DART AEROSPACE LTD	Work Order: 83841
Description: Crosstube Assembly	Part Number: D407-667-145
Inspection Dwg: D407-667-145 Rev: C	Page 1 of 1

DRAWING NO. D407-667-145	TITLE CROSSTUBE ASS'Y (407 HIGH FWD)	REV. C	DART AEROSPACE LTD ENGINEERING ORDER		D.E.O. NO. D407-667-145-C-1	SHEET NO. SHEET 1 OF 1	SCALE NTS
DRAWN <i>q</i>	CHECKED <i>ASS</i>	MFG. APPR. <i>IB</i>	APPROVED <i>WD</i>		DE APPR. <i>HB</i>		
DATE 11.07.15	DATE 11.07.22	DATE 11.07.22	DATE 11/07/22		DATE 11.07.21

PURPOSE:

REPLACE MAGNOBOND WITH PROSEAL.

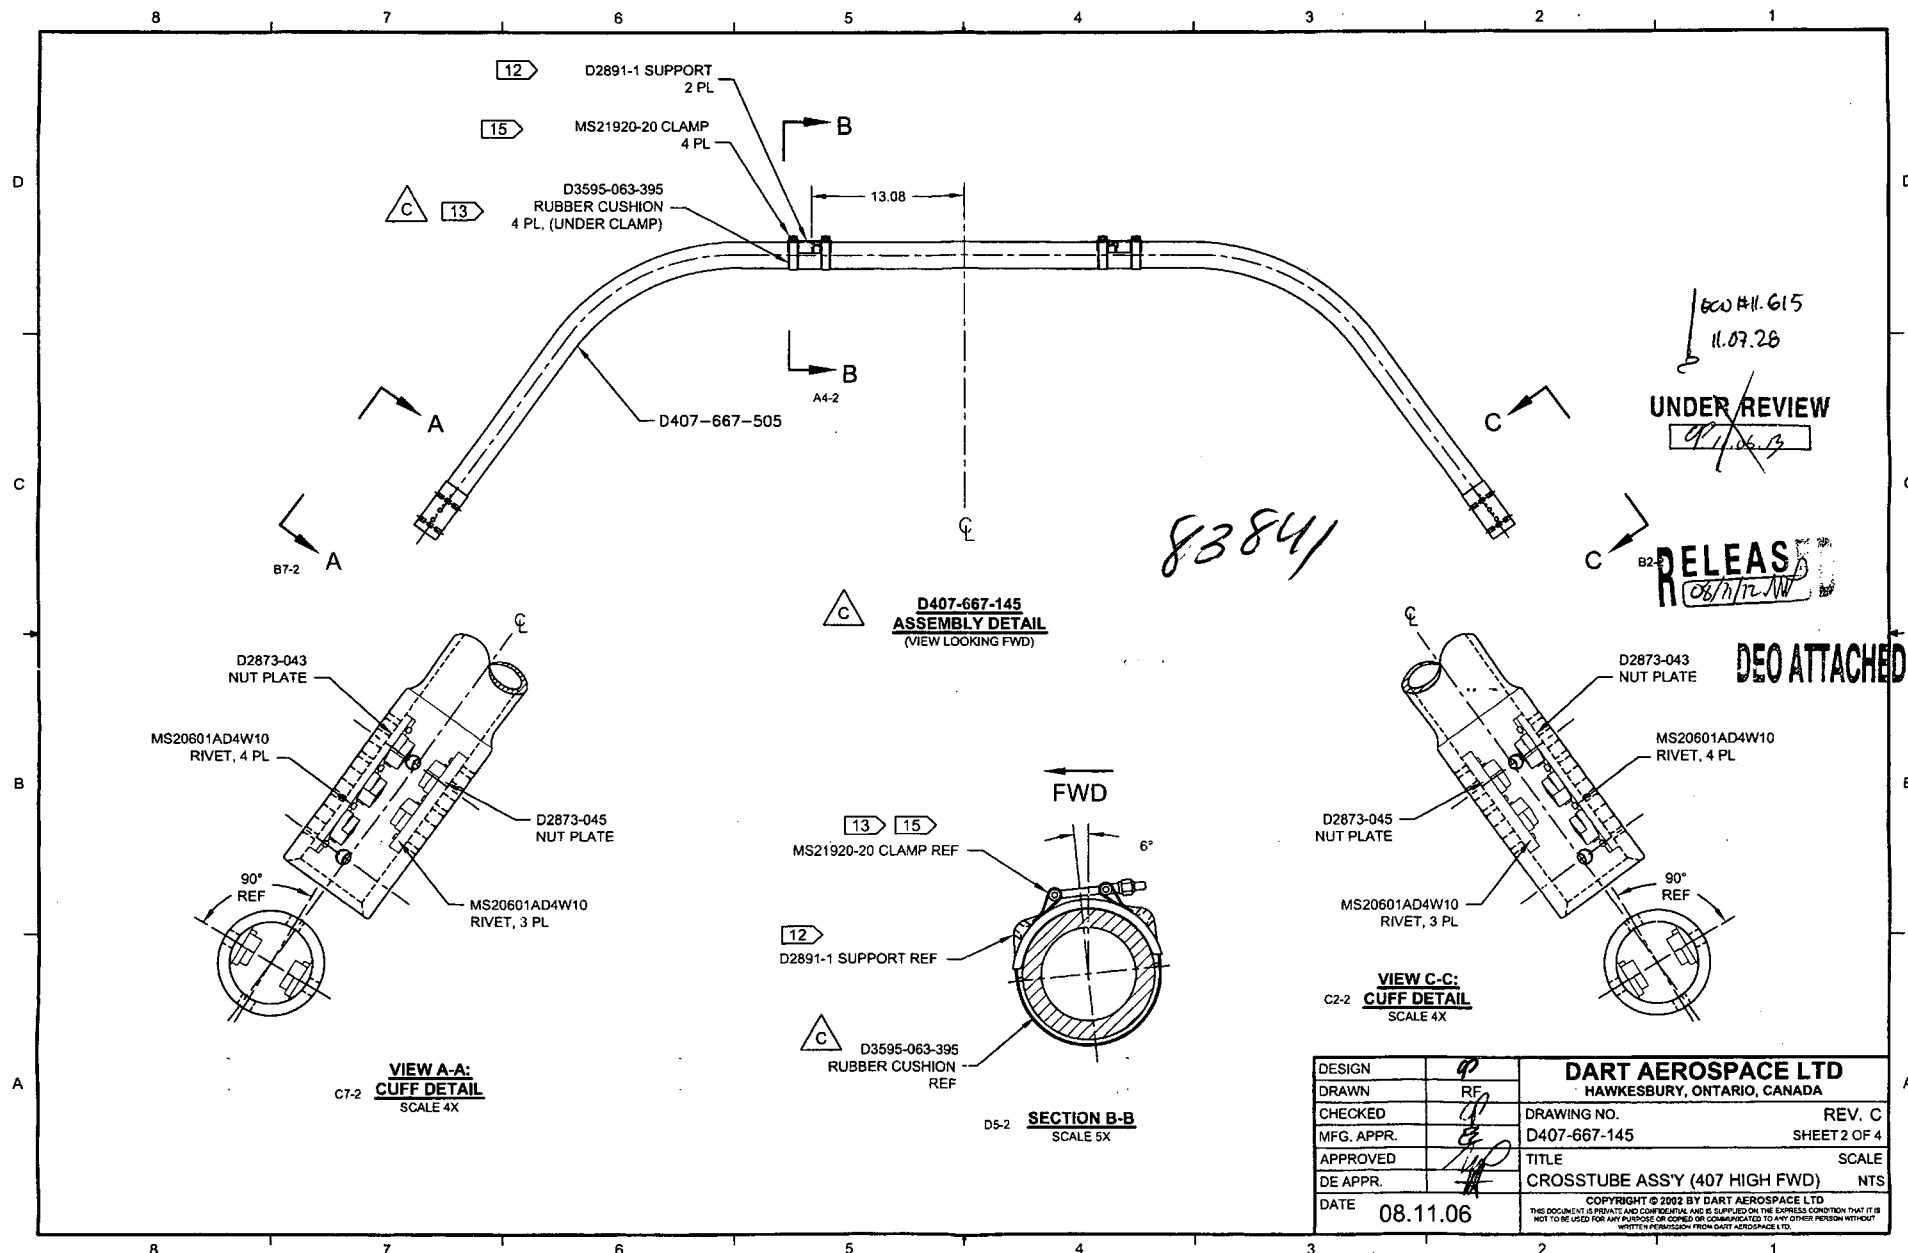
C	REVISE GENERAL NOTES/PART LIST (ZN D7-1); REORGANIZED VIEWS AND REFORMATTED DRAWING TO CURRENT STANDARDS. D3595-063-395 WAS D2856-400-694 (ZN D6-2 & A5-2); REMOVED REF. 7 ADD TOLERANCES (ZN C6-3, C4-3, D2-3); RELOCATED FLAG #6 (ZN A6-3) PER NCR 210; MOVED TURNING DETAIL & UPDATED TOLERANCE TO SHEET 4.	RF	08.11.06
B	ADD HOLES AND NUT PLATES FOR COMPATABILITY WITH BHT/AA SKUDTUBES	PH	05.07.26
A	NEW ISSUE	CP	02.05.08
REV.	DESCRIPTION	BY	DATE
DESIGN	RF	DART AEROSPACE LTD	
DRAWN	RF	HAWKESBURY, ONTARIO, CANADA	
CHECKED	RF	DRAWING NO.	REV. C
MFG. APPR.	RF	D407-667-145	SHEET 1 OF 4
APPROVED	RF	TITLE	SCALE
DE APPR.	RF	CROSSTUBE ASS'Y (407 HIGH FWD)	NTS
DATE	08.11.06	COPYRIGHT © 2002 BY DART AEROSPACE LTD THIS DOCUMENT IS PRIVATE AND CONFIDENTIAL AND IS SUPPLIED ON THE EXPRESS CONDITION THAT IT IS NOT TO BE USED FOR ANY PURPOSES OR COPIED OR COMMUNICATED TO ANY OTHER PERSON WITHOUT WRITTEN PERMISSION FROM DART AEROSPACE LTD.

TURNING DETAIL

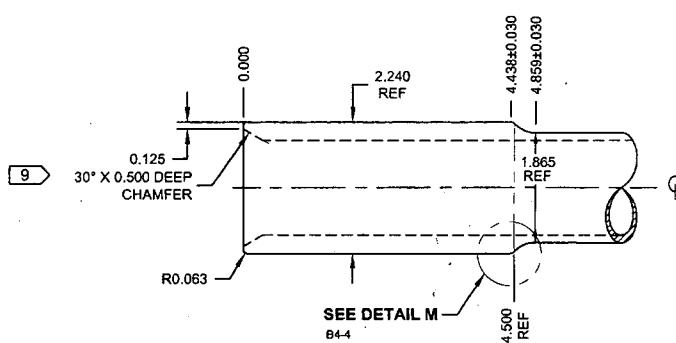
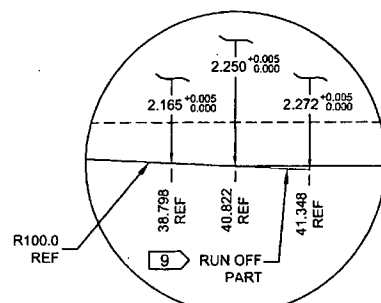
- WEIGHT: 17.8 lbs
- PART IS SYMMETRIC ABOUT CENTERLINE.
- RUN CUTTER OFF PART WHERE INDICATED. BLEND OUT EDGE LONGITUDINALLY. TRANSITION SHOULD BE SMOOTH.
